17014

September 26, 2017

**Preliminary & Final Application - Major Subdivision and Site Plan**  
**Higbee Notch Apartments**  
**251 Gray Road**  
**Cumberland, Maine**  
**Cumberland Assessor's Map U21 Lot 18**  
**Denise Morgan, Megan Morgan and Nathan Pelsinski**  
**Response to Comments and Final Application Materials**

TYPICAL ROAD SECTION  
NOT TO SCALE

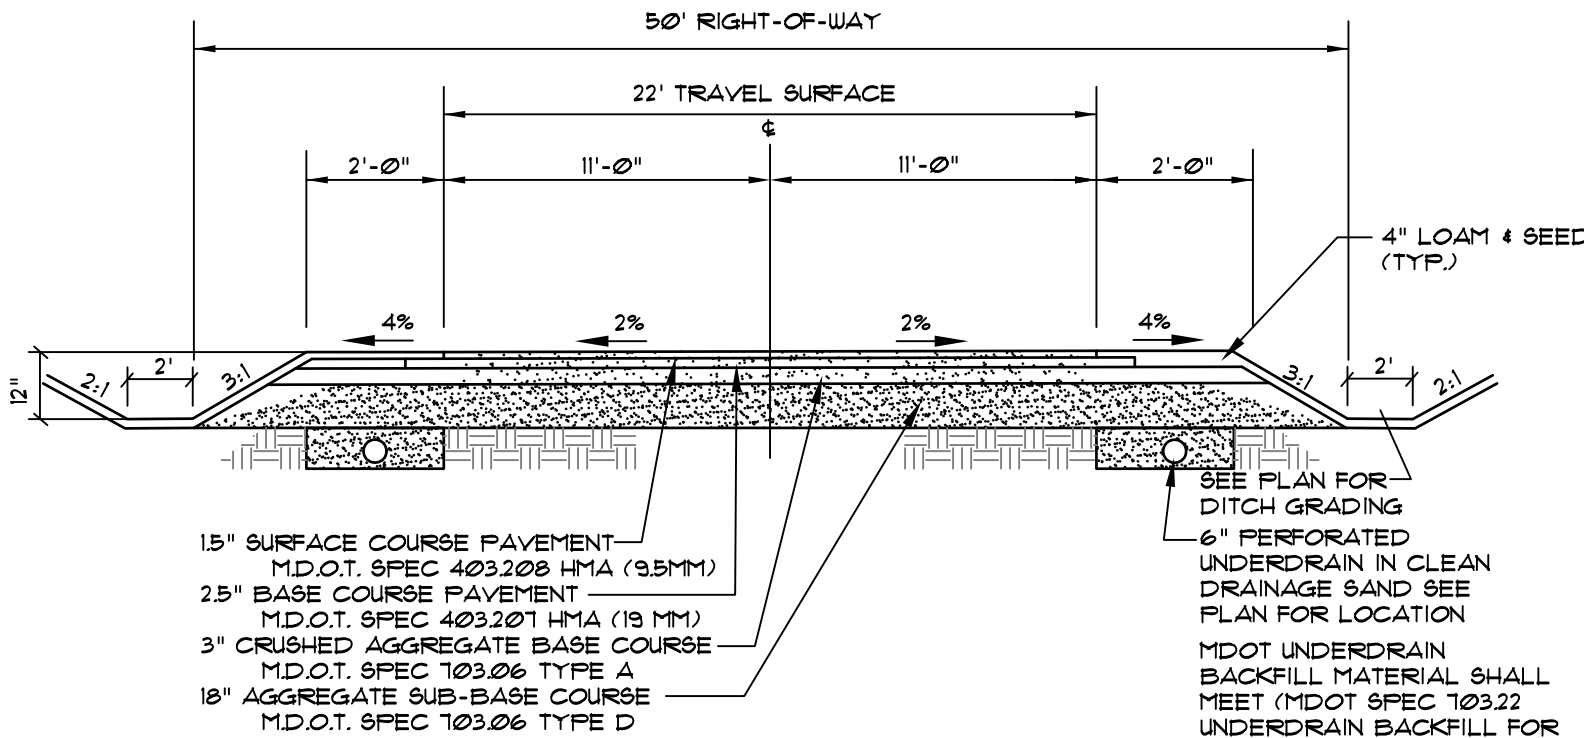
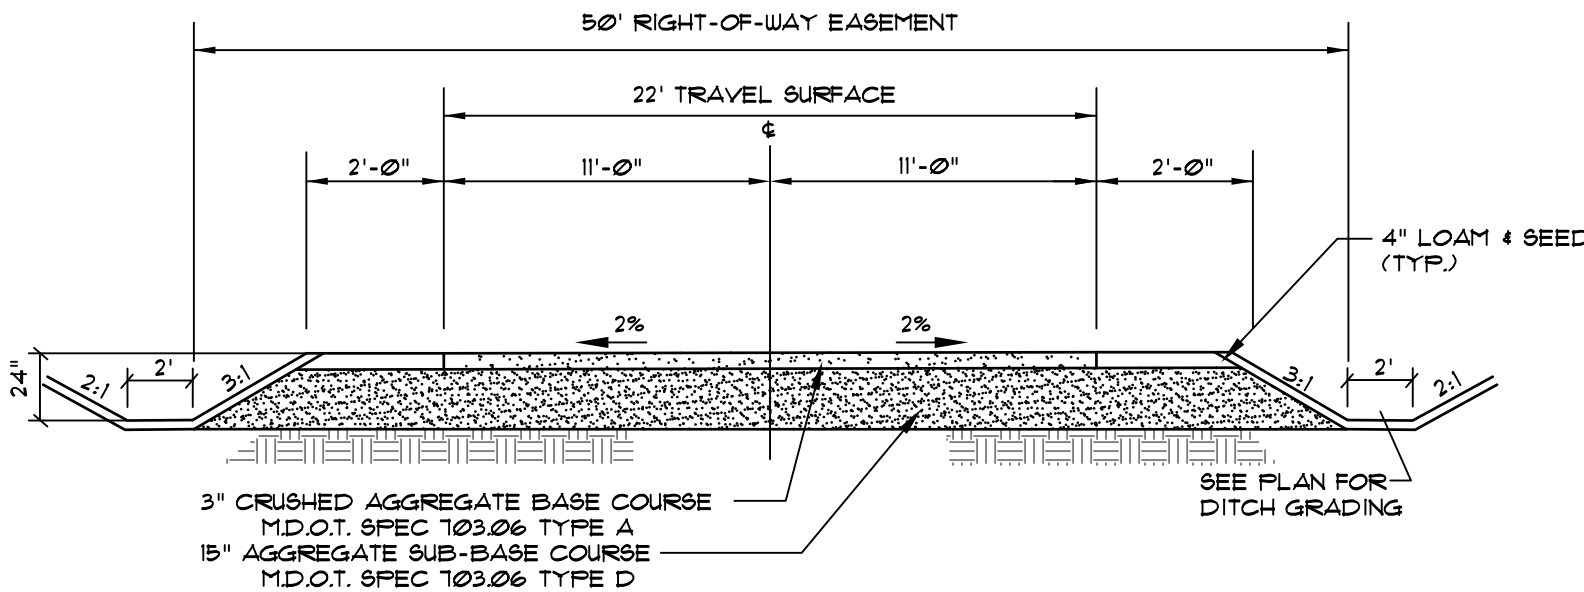
- **Underdrains in the approximately 105' long Higbee Lane** - As discussed during the Planning Board meeting on September 19, 2017, the Applicants are requesting a waiver of to eliminate underdrains in the approximately 105' long section of Higbee Lane. The typical roadway section noted in the Ordinance includes relatively shallow ditches (approximately 12" deep) and underdrains to drain the road section.

In lieu of underdrains, our office has designed a deeper ditch section (approximately 30" deep along Higbee Lane) to allow the subgrade to drain to daylight (please note that the ditch depth has been increased to 30" in this area to accommodate the thicker municipal roadway section appropriate for a residential access road serving greater than 50 vehicle trips per day - as noted in Sevee & Maher Engineer's (SME's) peer review comments).

In addition, the ditchline grading along Higbee Lane has been increased to approximately 30" deep to accommodate the requested waiver for installation of underdrains. Spot grades have been added to the grading plan as well to clarify the requisite ditch depths along Higbee Lane.

Spot grades and detailed ditch grading have been added to the plans to provide a minimum depth of ditch dimension of 30” in the section of Higbee Lane, and 24” minimum ditch depth along the shared gravel access drive. Based on the cross sectional information for Higbee Lane, the 30” minimum ditch depth will allow the road subgrade beneath the 25” road section to drain to daylight. Likewise, the 24” deep ditch section along the shared gravel access drive will allow the subgrade beneath the 21” gravel road section to drain to daylight as well. Please see the discussion regarding the waivers of underdrains in Higbee Lane presented earlier in this letter.

TYPICAL CONCRETE PAD & ENCLOSURE  
NOT TO SCALE

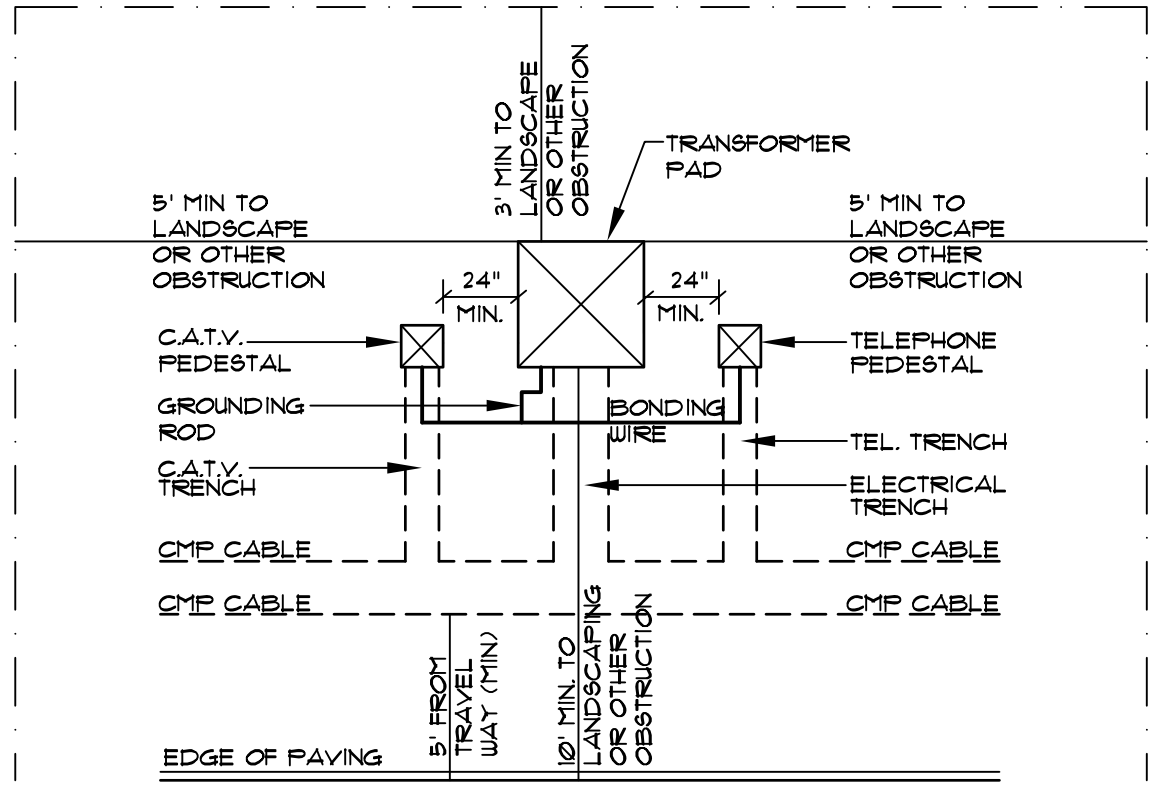
As noted during the Planning Board presentation on September 19, 2017, in Phase 1, the residents' trash and recyclables will be placed off the southeast corner of the turnaround at Higbee Lane on the designated weekly pick-up day. This location is approximately 100' off Route 100. In Phase 1 there will be only four apartments on the site, one of which will be the Applicants'.

As discussed during the Planning Board presentation, at the time of construction of the building in Phase 2 (when there will be a total of 8 apartments on the site), this area will be formalized with the construction of a concrete pad and enclosure, as shown on the enclosed plans.

PADMOUNT TRANSFORMER  
& CABLE LAYOUT DETAIL  
NOT TO SCALE

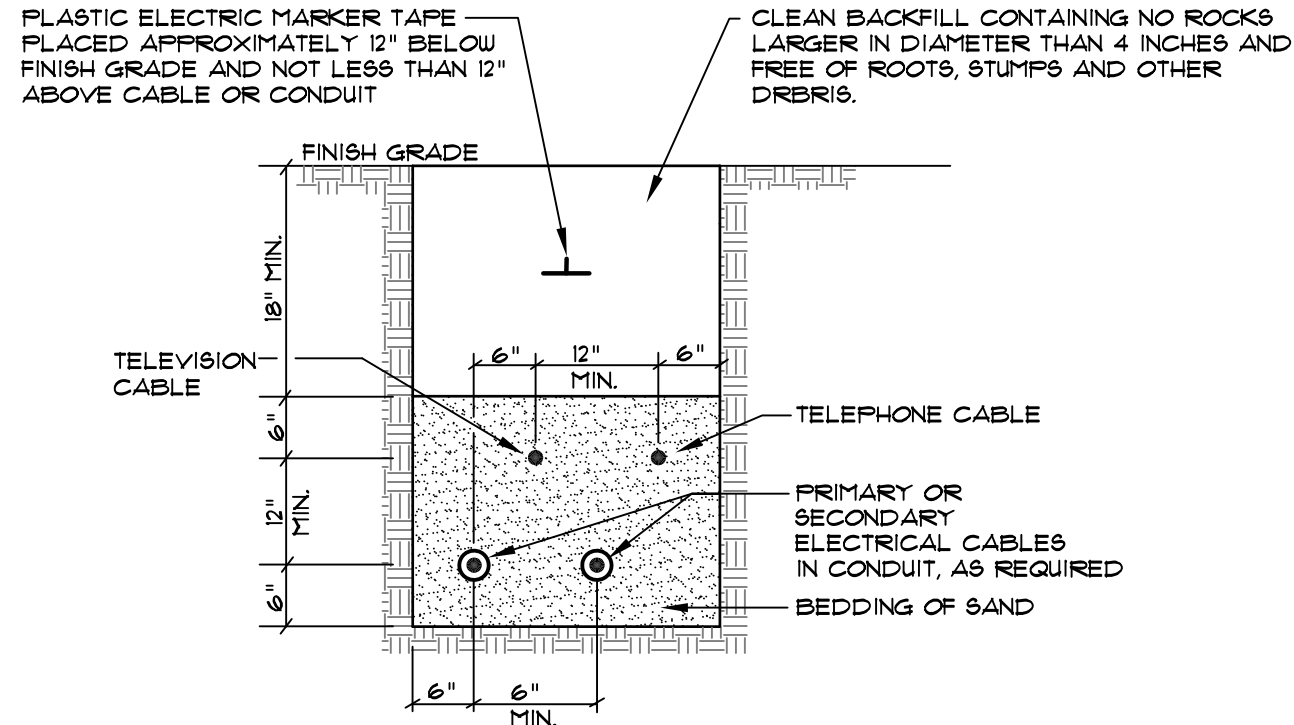
1. *Utilities shall be installed underground except as otherwise approved by the Board. Plans include approximately 300 lf of overhead electric and telephone service into the property. SME recommends the Board review the proposed installation prior to approval.*

Since the Planning Board meeting, the Applicants have coordinated directly with Central Maine Power Company to discuss the power supply configuration for this site. CMP has indicated that they will require a pole placed approximately 200' to 220' from Route 100, with a support pole approximately 20' from the new pole. From this point the service would be underground to an approximately 4' by 4' pad mounted transformer, which will provide underground services to each apartment building.

This updated service configuration is shown on the enclosed revised plans. This reduces the extent of overhead line length by approximately 80' to 100' from that which was shown on the prior plans. Although the extent of overhead utility lines has been reduced, the Applicant must still seek a waiver on this item.
